SUBJECT: ISSUANCE OF AMENDMENT NO. 13 TO FACILITY OPERATING LICENSE NO. NPF-38
FOR WATERFORD 3

ISSUANCE OF AMENDMENT NO. 13 TO FACILITY OPERATING
LICENSE NP. NPF-38 FOR WATERFORD 3

ATTACHMENT TO LICENSE AMENDMENT NO. 13
TO FACILITY OPERATING LICENSE NO. NPF-38
DOCKET NO. 50-382

SAFETY EVALUATION BY THE OFFICE OF NUCLEAR REACTOR REGULATION
SUPPORTING AMENDMENT NO. 13 TO FACILITY OPERATING LICENSE NO. NPF-38

FIGURE 3.1-3 PART LENGTH CEA INSERTION LIMIT VS. THERMAL POWER

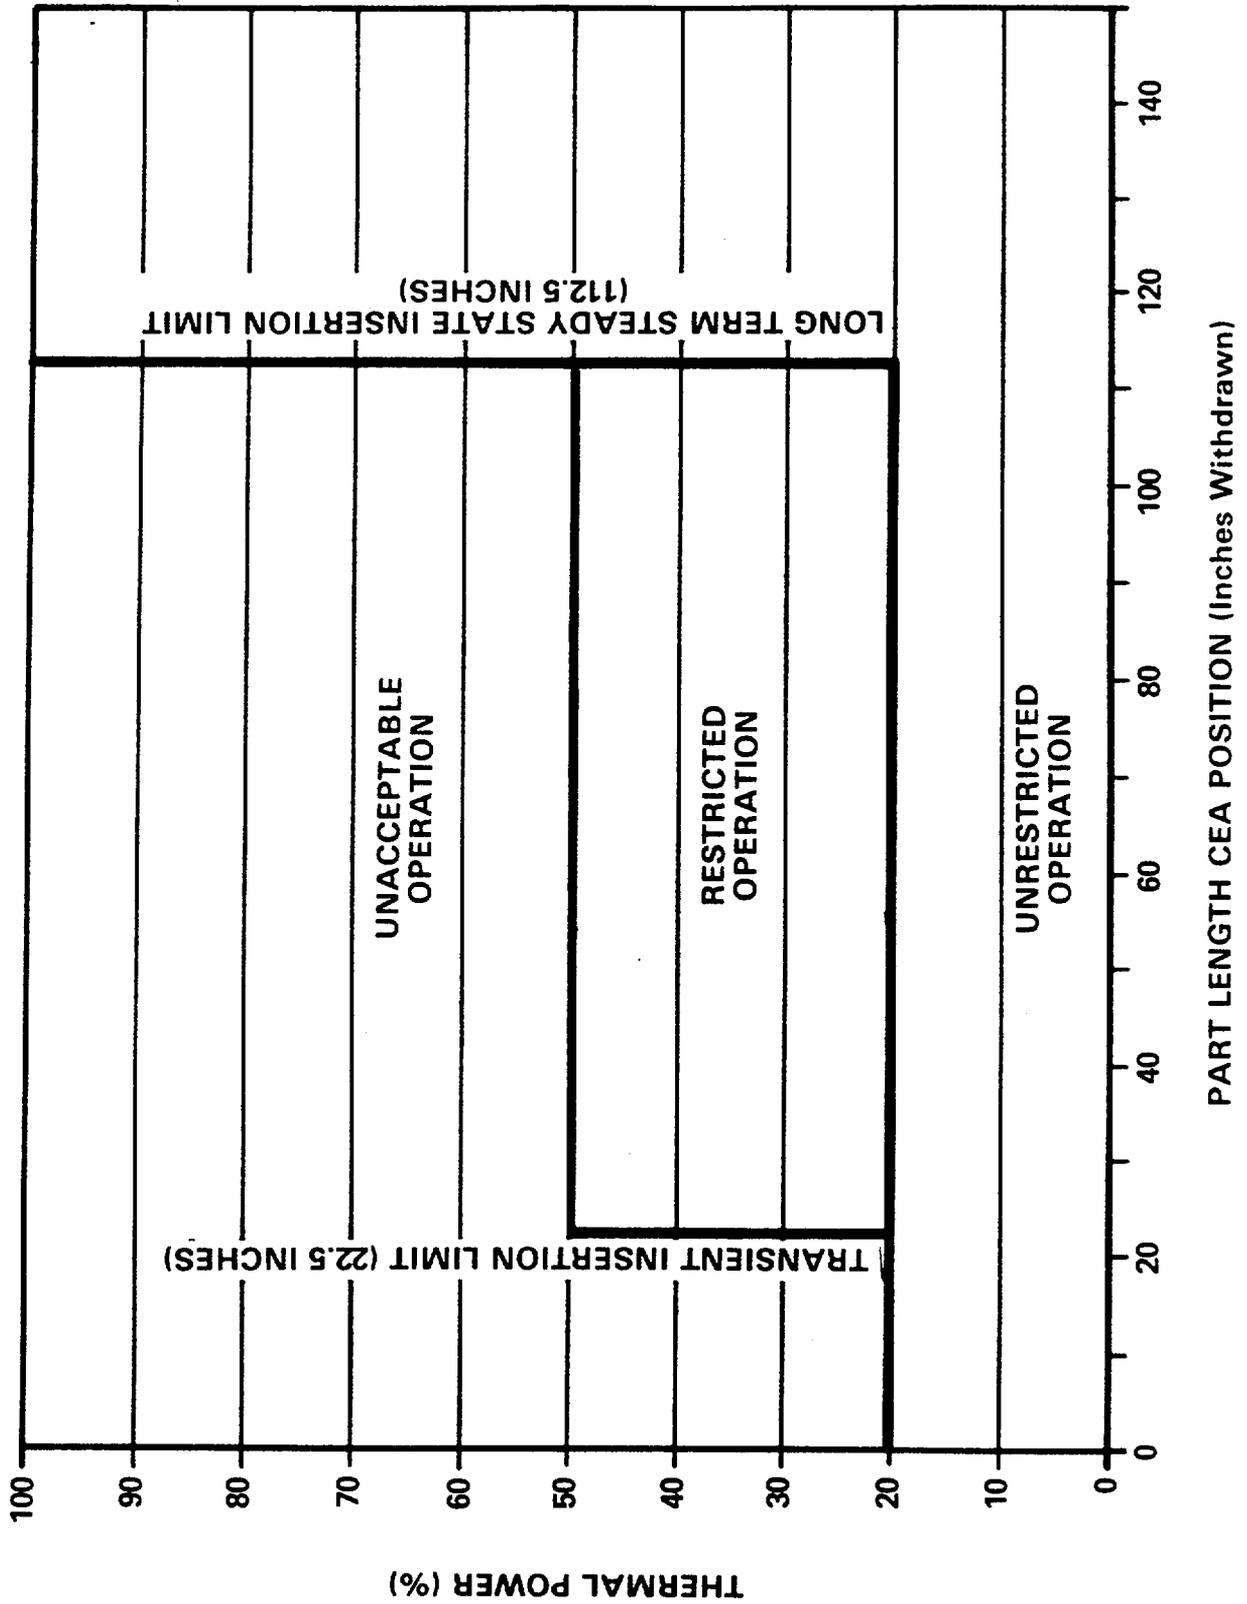
The proposed change adds Figure 3.1-3 which allows a maximum PLCEA insertion of 25% (112.5 inches withdrawn) during long term steady state operation above 20% power and allows a maximum transient PLCEA insertion of 85% (22.5 inches withdrawn) between 20% and 50% power for no longer than 7 EFPD out of any 30 EFPD period or 14 EFPD per calendar year. Since PLCEA insertion below 20% power has a negligible effect on axial burnup distribution as well as on axial power peaking, any PLCEA insertion below 20% power is allowed. The proposed change, therefore, would impose more restrictive limits on allowable PLCEA insertion limits than do the current Technical Specifications above 20% of thermal power.

These more restrictive PLCEA insertion limits make the consequences of anticipated operational occurrences such as a PLCEA drop less severe than previously analyzed when any pre-drop position was allowable. These more restrictive limits also provide additional assurance that adverse axial shapes and rapid local power changes which affect radial power peaking factors and DNB considerations do not occur as a result of the PLCEAs being positioned in the same axial segment of fuel assemblies for an extended period of time.

3.1.3.7 The part length CEA groups shall be limited to the insertion limits shown on Figure 3.1-3 with PLCEA insertion between the Long Term Steady State Insertion Limit and the Transient Insertion Limit restricted to:

- a. ≤ 7 EFPD per 30 EFPD interval, and
- b. ≤ 14 EFPD per calendar year.

Therefore, since the proposed change imposes more restrictive limits as well as surveillance requirements to ensure adherence to these limits, and results in improvements in the potential consequences of related anticipated operational occurrences, the staff finds it acceptable.
